CALIFORNIA COASTAL COMMISSION

ADDENDUM

DATE: December 10, 2012
TO: Commissioners and Interested Parties
FROM: South Central Coast District Staff
SUBJECT: Agenda Item Th8a, Application No. 4-12-003 (Rydings), Thurs., December 13, 2012

Exhibit 11
Visual Resource Areas
CDP No. 4-12-003

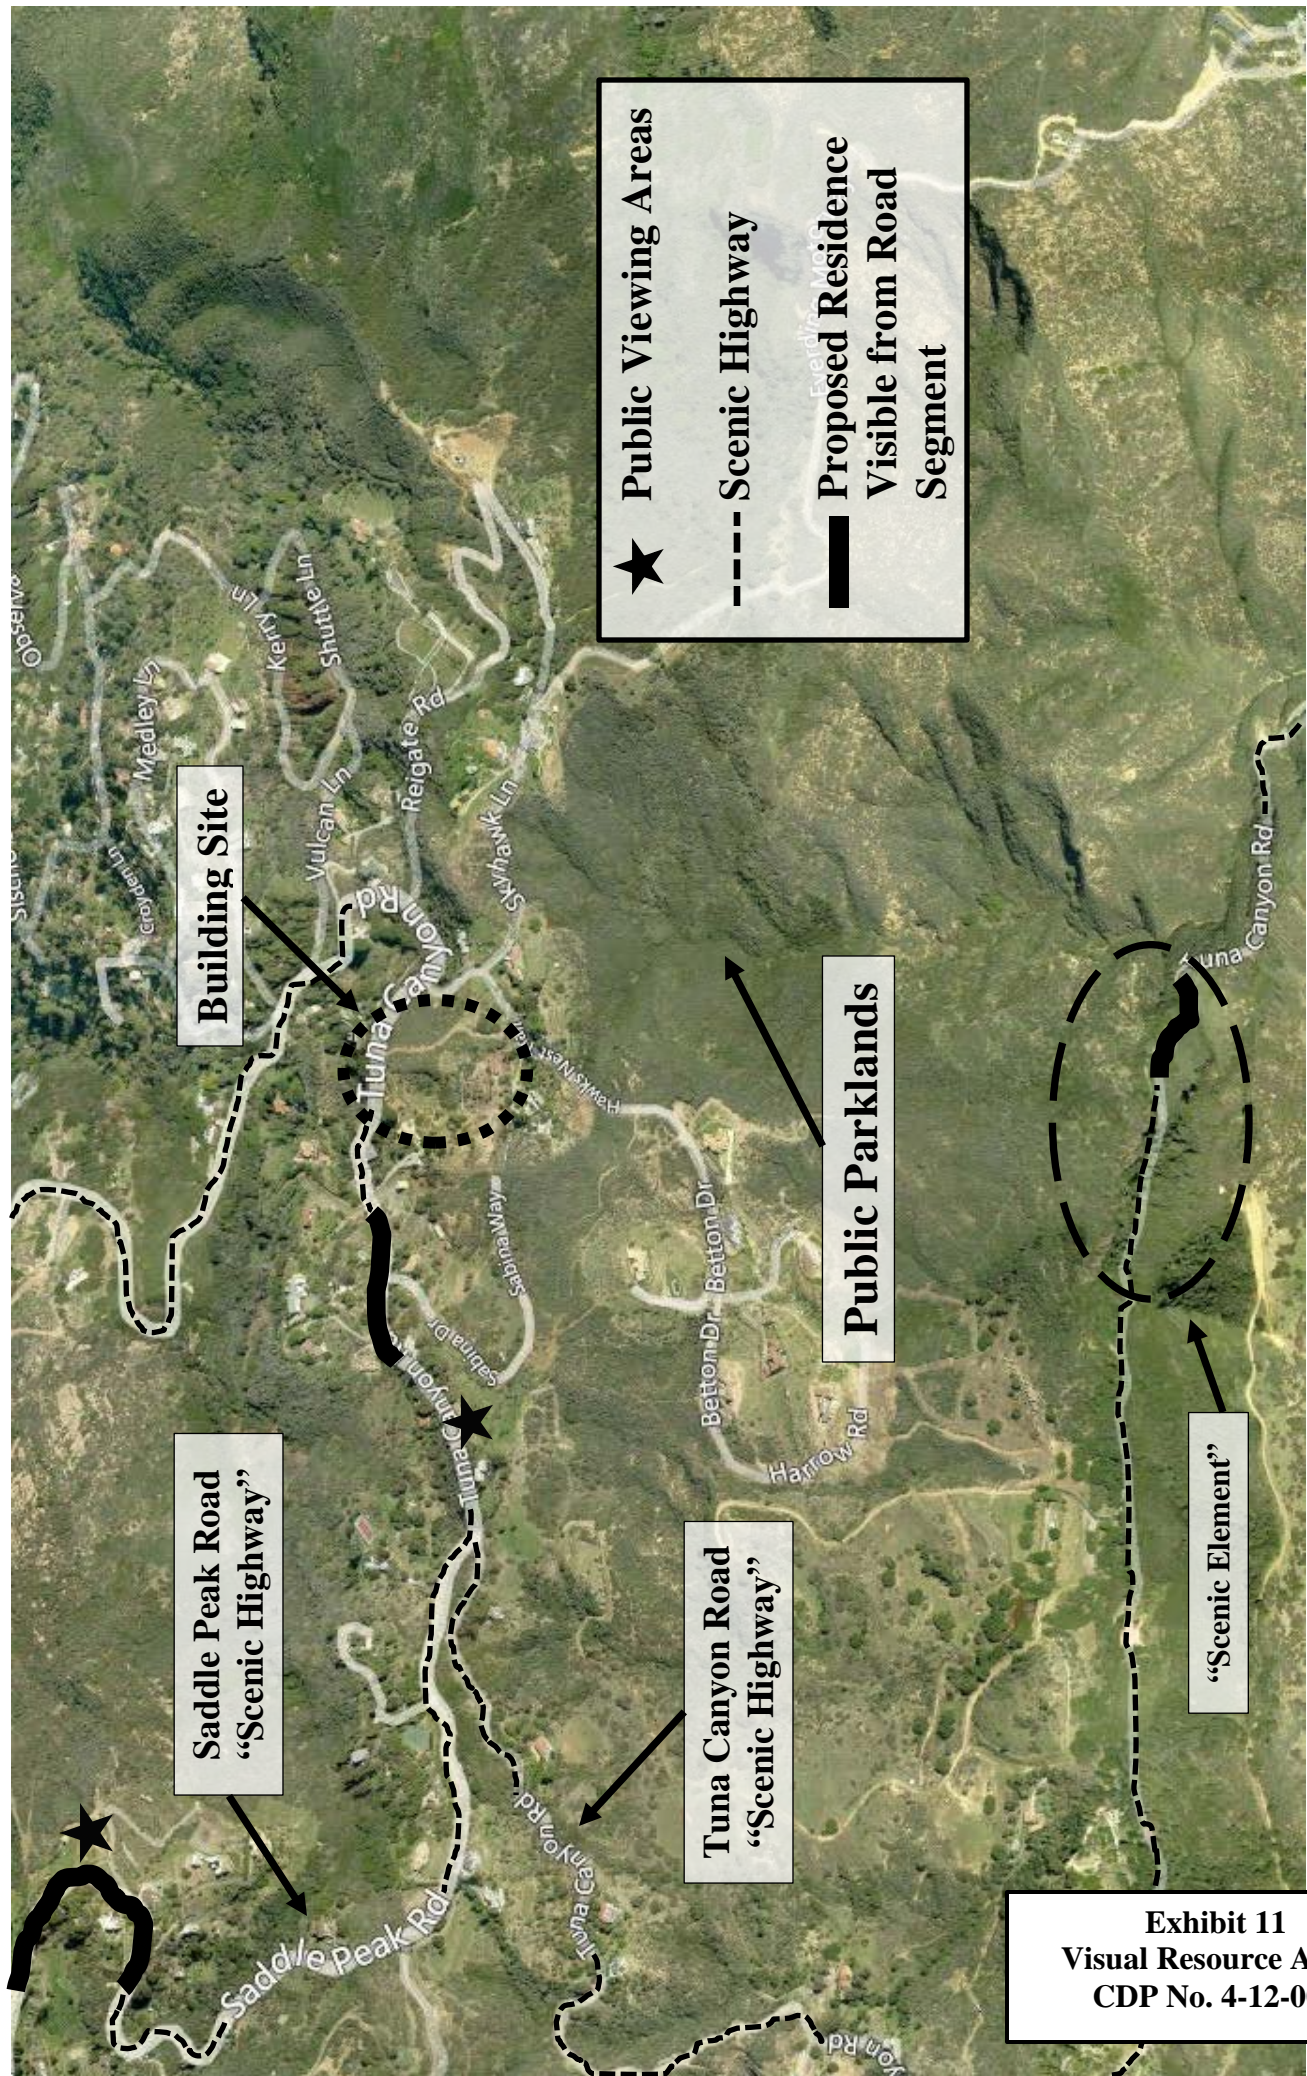
- 3.) The following change shall be made to Exhibit 11 of the November 29, 2012 staff report, to include correct an inadvertent error in the placement of the Public Viewing Area “star.” Currently, Exhibit 11 of the staff reports depicts the Public Viewing Area “star” north of Tuna Canyon Road, which is in the incorrect location and instead should be located south of Tuna Canyon Road. Attached to this addendum is a revised Exhibit 11 to reflect the change noted above.
- 4.) Attached to this addendum is documentation of an ex-parte communication received from Commissioner Zimmer dated December 10, 2012.
